UNITED STATES
NUCLEAR REGULATORY COMMISSION
WASHINGTON, D. C. 20555

MEMORANDUM FOR: Docket File 71-6698

SUBJECT: MEETINGS WITH APPLICANTS CONCERNING APRIL 6, 1979
ORDER TO SHOW CAUSE

NUCLEAR FUEL S
 NFS-4
 CASK SH 1,244
 E 1173

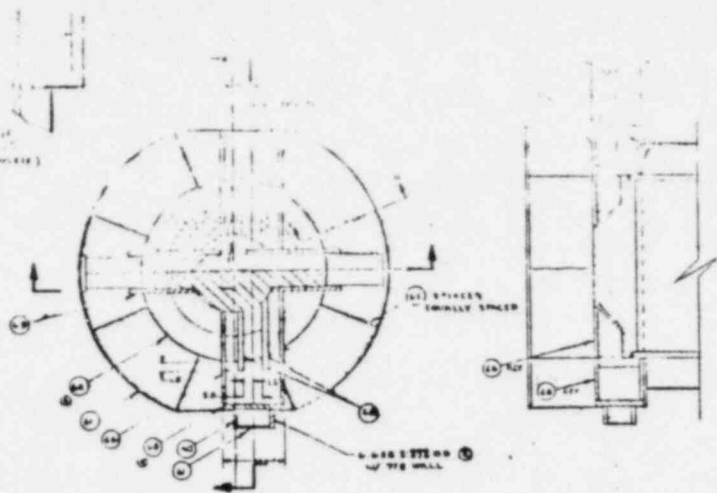
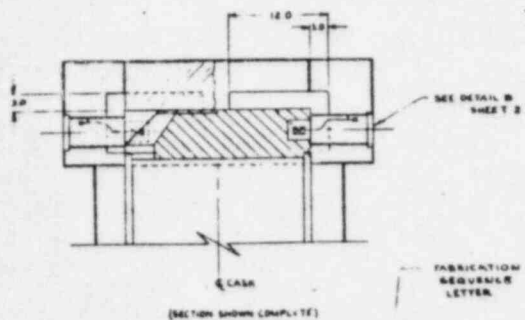
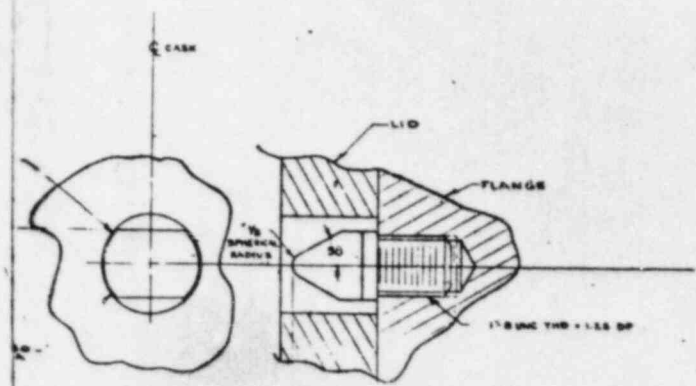
NAC indicated at the meeting that the 0.13 inch straightness criteria shown on the package drawing was only for ease of inserting and replacing the fuel basket and is not discussed in the safety analysis report for the package design. The NRC staff indicated if this is true, then before the packagings could be returned to service an unreviewed safety question (possibility of buckling of the containment vessel) would have to be resolved. This could be done by reference to recognized standards and codes or by analysis.

NAC left the staff with a marked-up copy of proposed changes to the drawing for the Model No. NFS-4 packaging (4 sheets).
